SERVICE BULLETIN

THE EXTERIOR HOUSING OF A DUO-PAK® AVIOX® PORTABLE OXYGEN EQUIPMENT UNIT CAN BE DAMAGED IF THE INSTRUCTIONS ARE NOT FOLLOWED AND EXCESS TORQUE IS USED TO TIGHTEN THE ACTUATOR WHEN INSTALLING AN OXYGEN GENERATOR.

This Service Bulletin applies to the P/N 802512 Series AVIOX® Duo-Pak® portable oxygen units listed in Table 1 that were manufactured between 1995 and January 15, 2008 by AVOX Systems and its predecessor, Scott Aviation.

Label 10006967
Figure 2

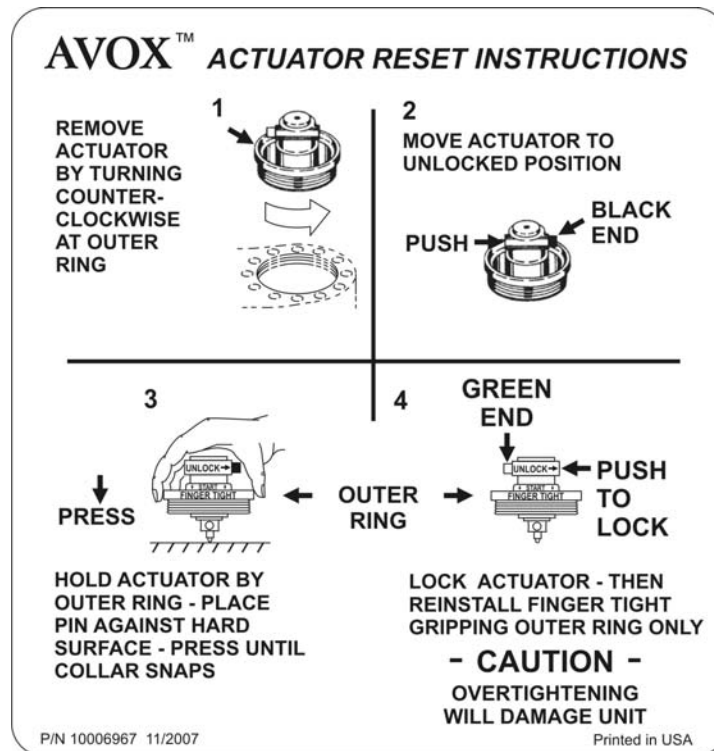
C. Remove the existing label 10006967 (see Figure 2) or, if the label is firmly attached, sand lightly, wipe and let dry.

D. Attach the new label 10006967 (see Figures 2 and 3) over the existing label or in place of the removed label as applicable.

A new instruction label and revised instructions will be provided to emphasize the proper procedure for installing a chemical oxygen generator in the P/N 802512 units.
